DAVID PLUMMER & ASSOCIATES

Re: Mediterranean Village Review - #14153
Traffic Impact Study, Parking Analysis & Valet Operations Analysis

David Plummer and Associates (DPA) have completed several reviews of the Traffic Impact Analysis, Shared Parking Analysis, Parking Garage, and Valet Operation Analysis conducted for the proposed Mediterranean Village project. A summary of these components is below.

HOTEL DROP-OFF - OPTION #1 “ORIGINAL SUBMISSION”

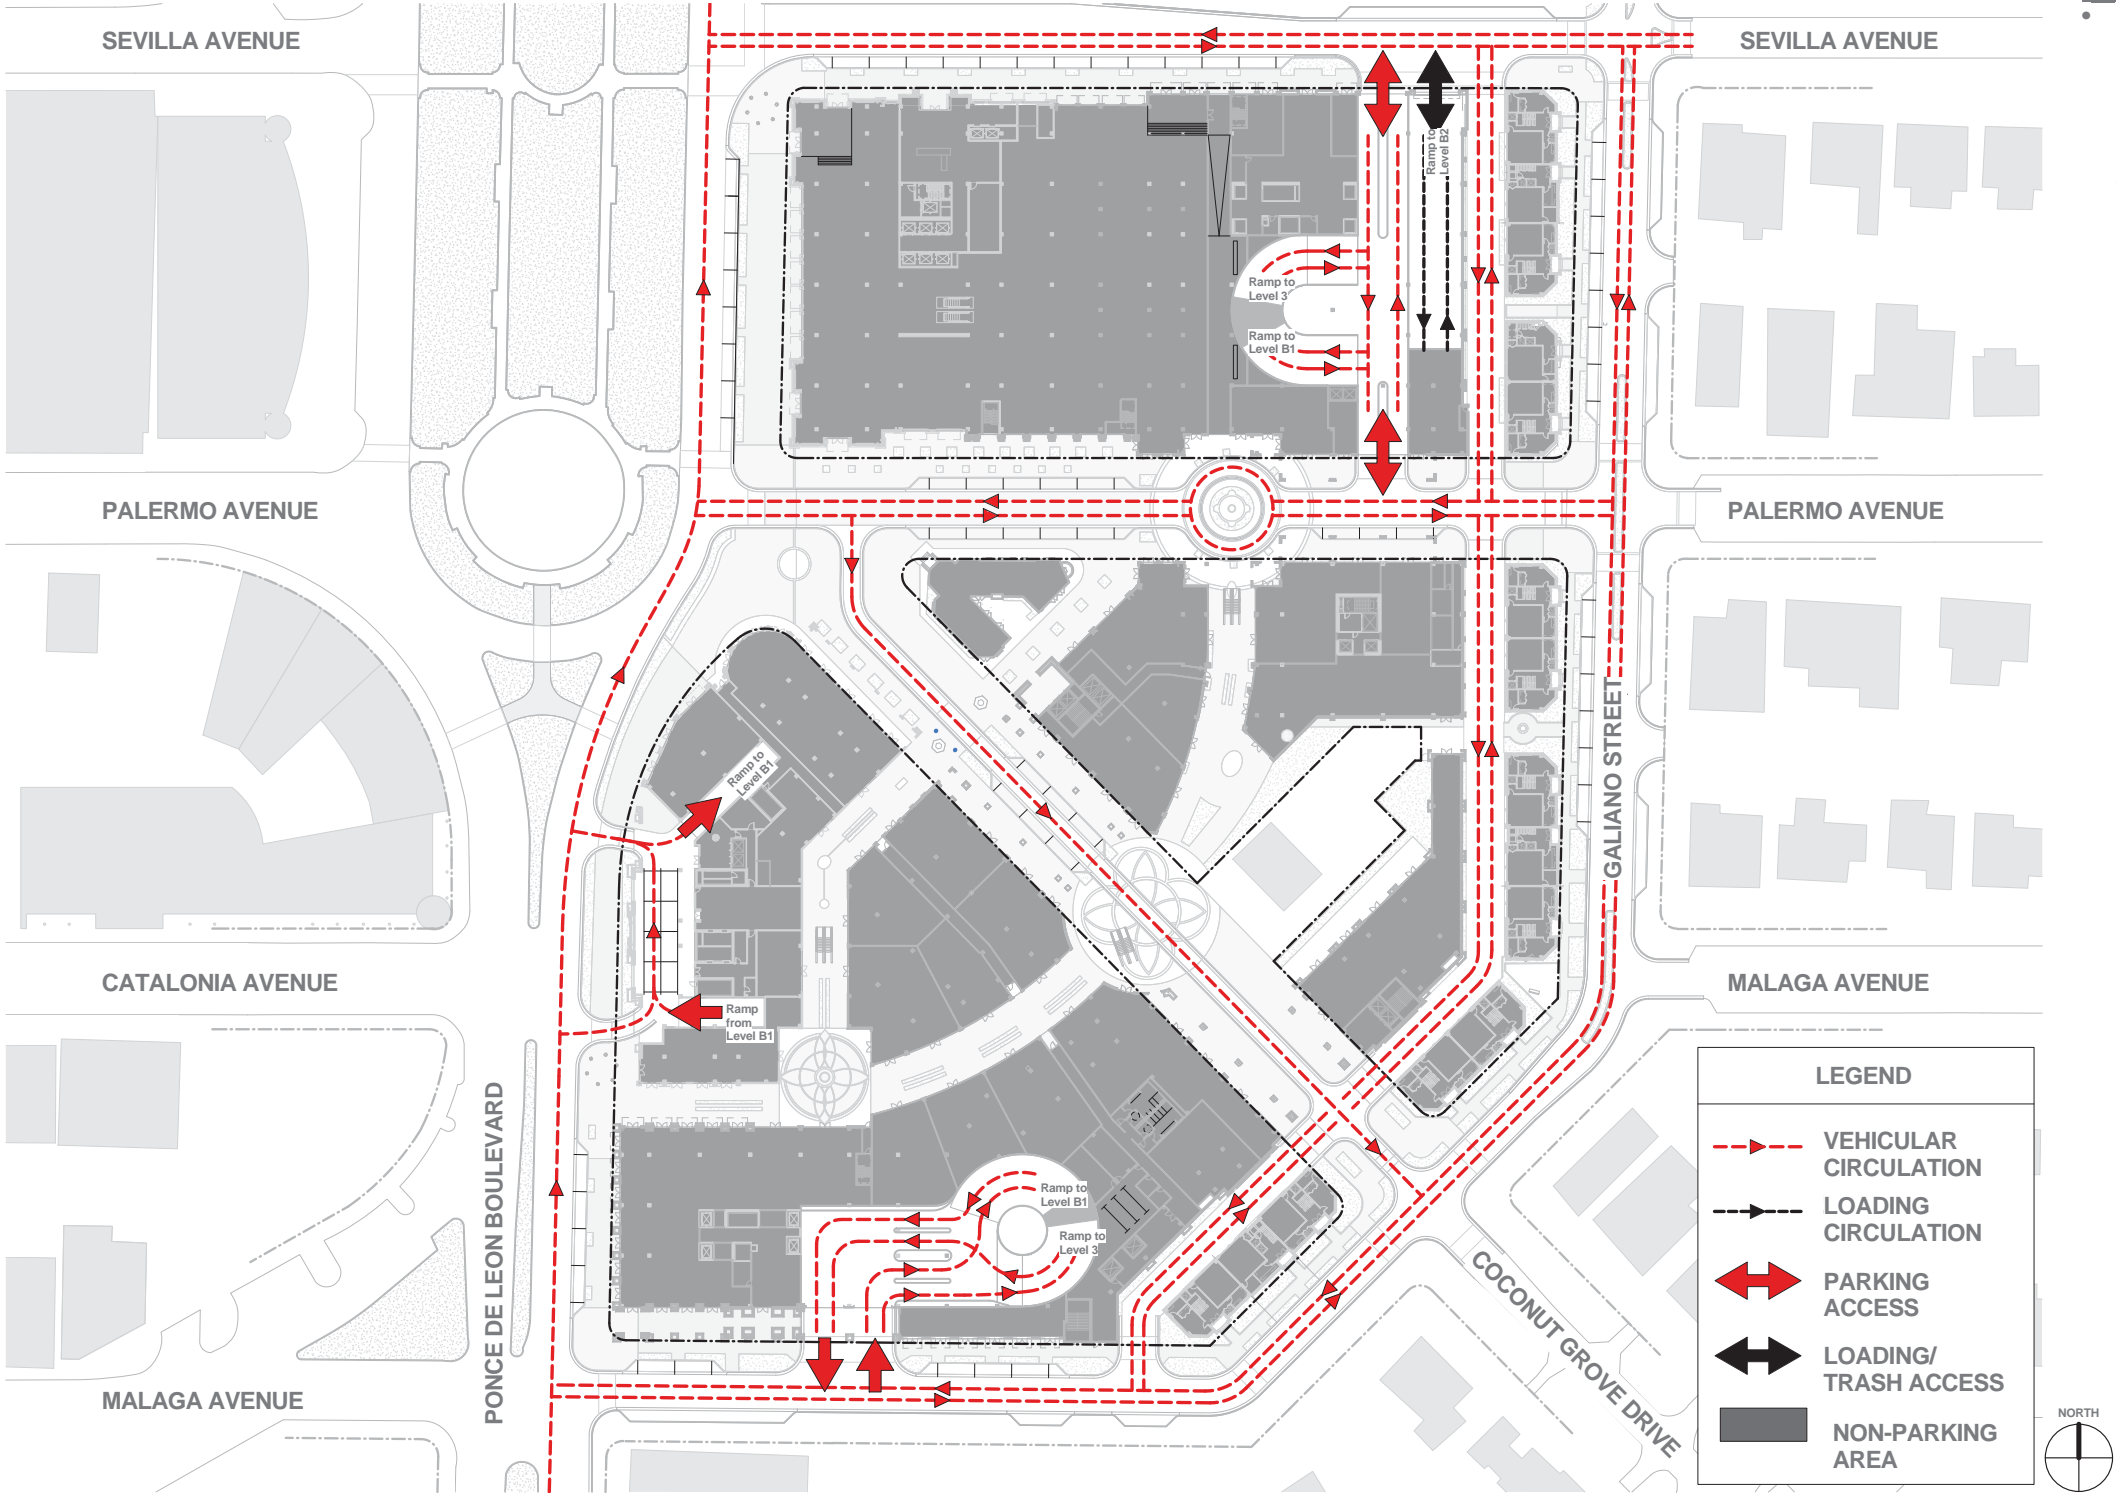
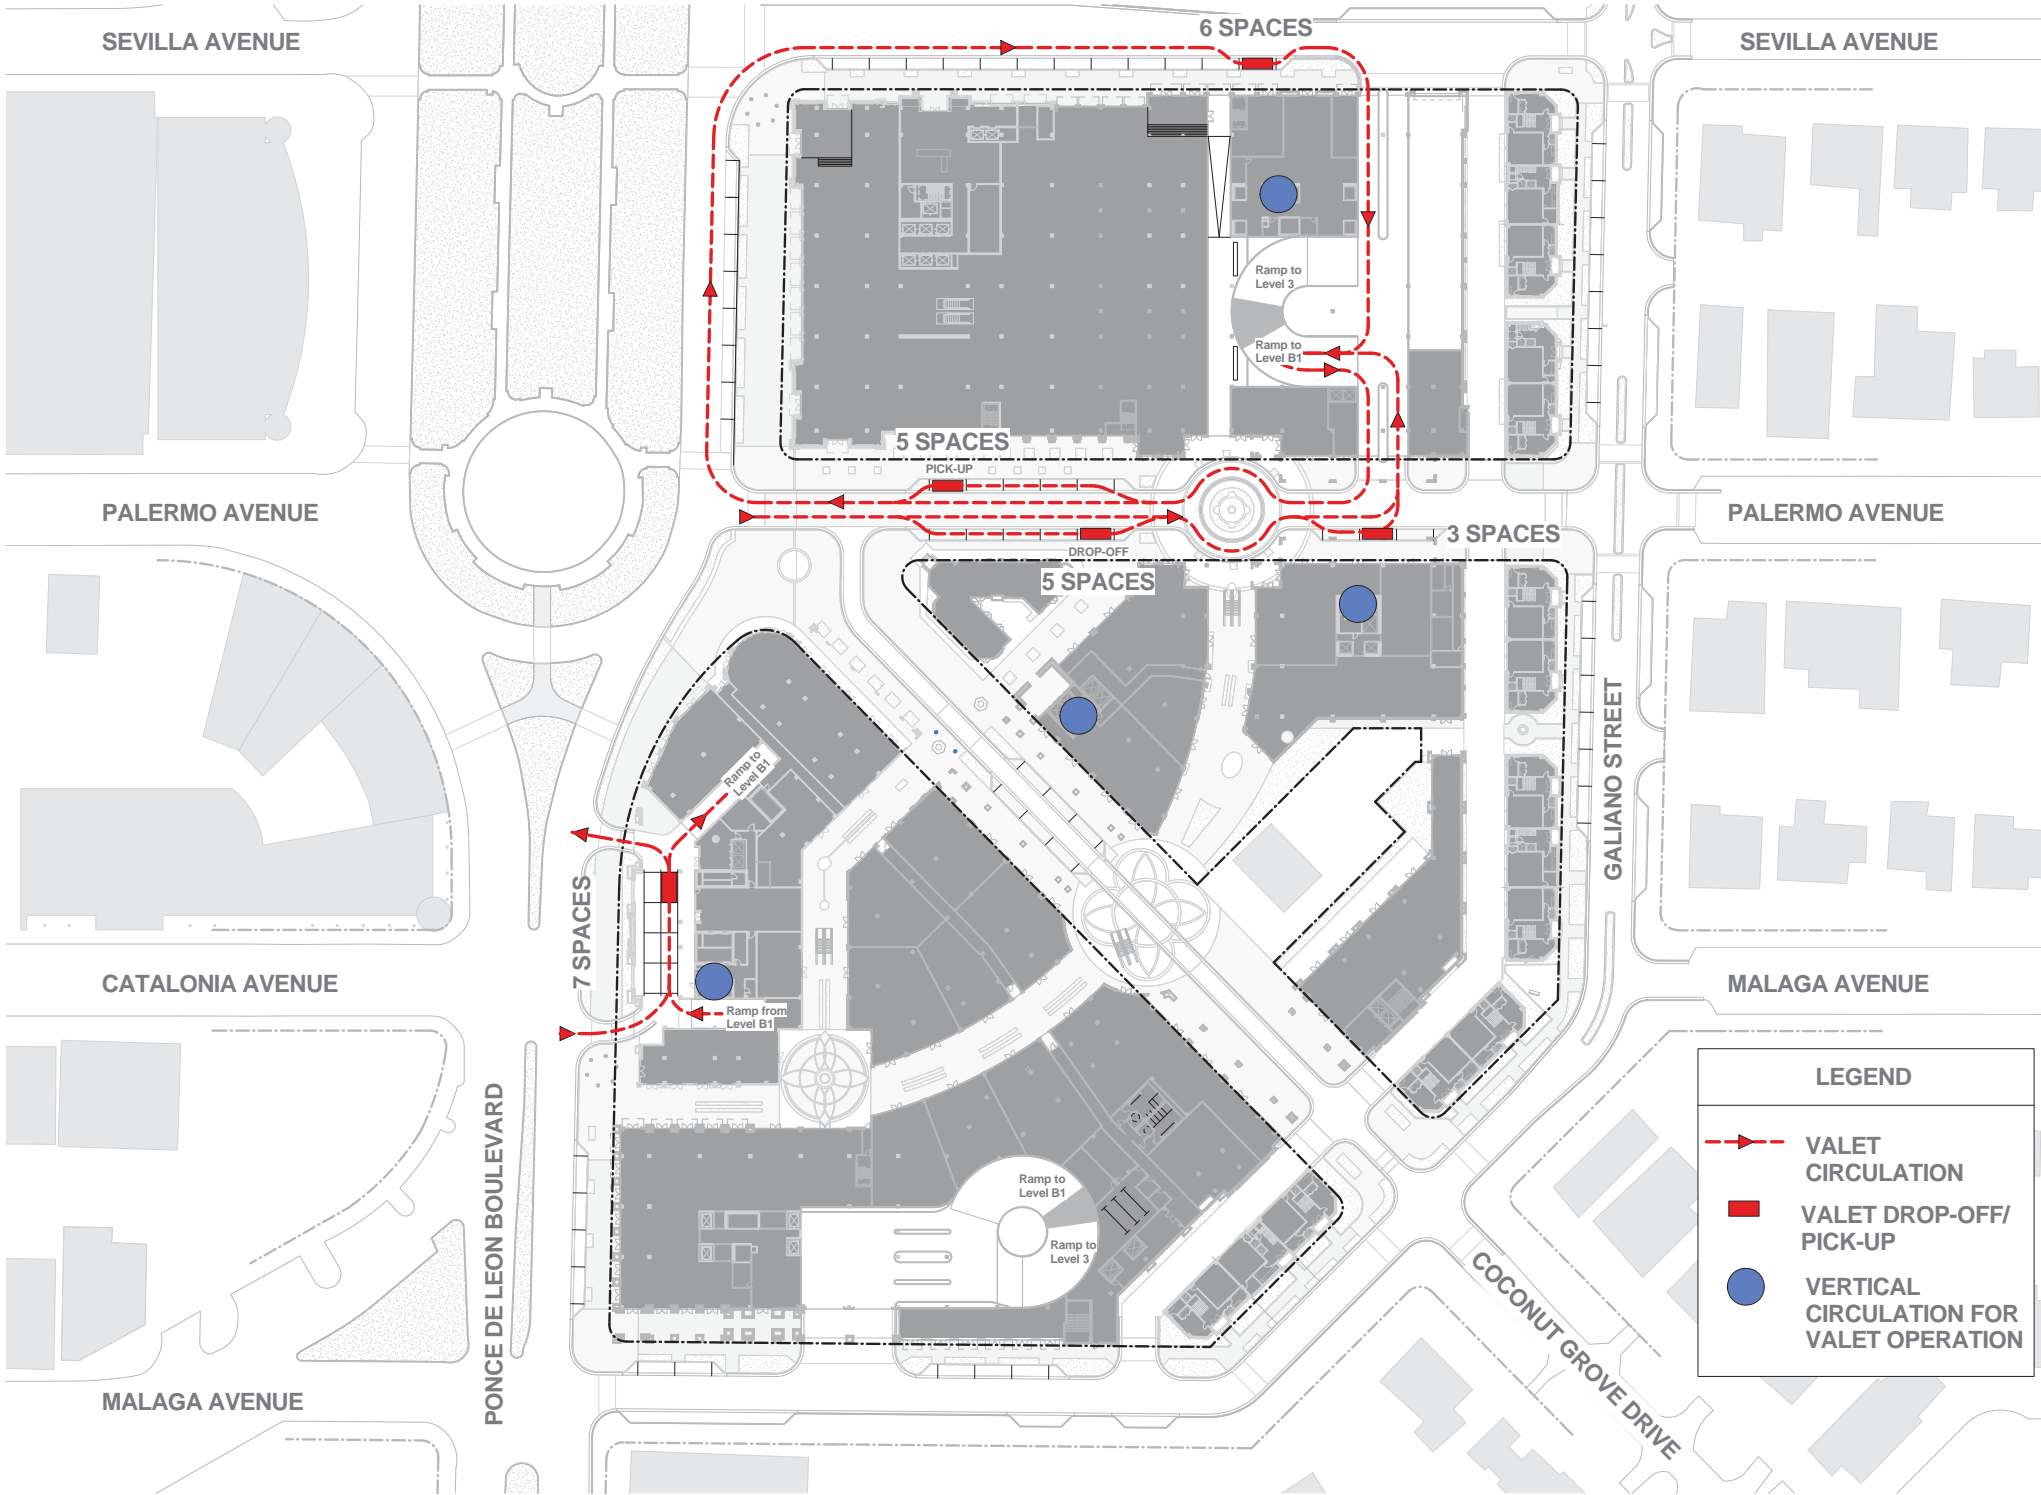
During first reading, the project included direct access to the hotel from Ponce. This access plan for the hotel was acceptable. The project has since changed to address comments from the Commission. Of the newly proposed options, Option 3 is an acceptable alternative and preferable to Option 2 provided that the following conditions are included: 1) the hotel valet ramps will be completely segregated from the Malaga driveway ramping system and no traffic from Malaga would be allowed to access the hotel's porte cochere, and 2) two one-way ramps (similar to the Ponce alternative) or a two-way, two-lane ramp for hotel valet use only is provided. See attachments for hotel access options.
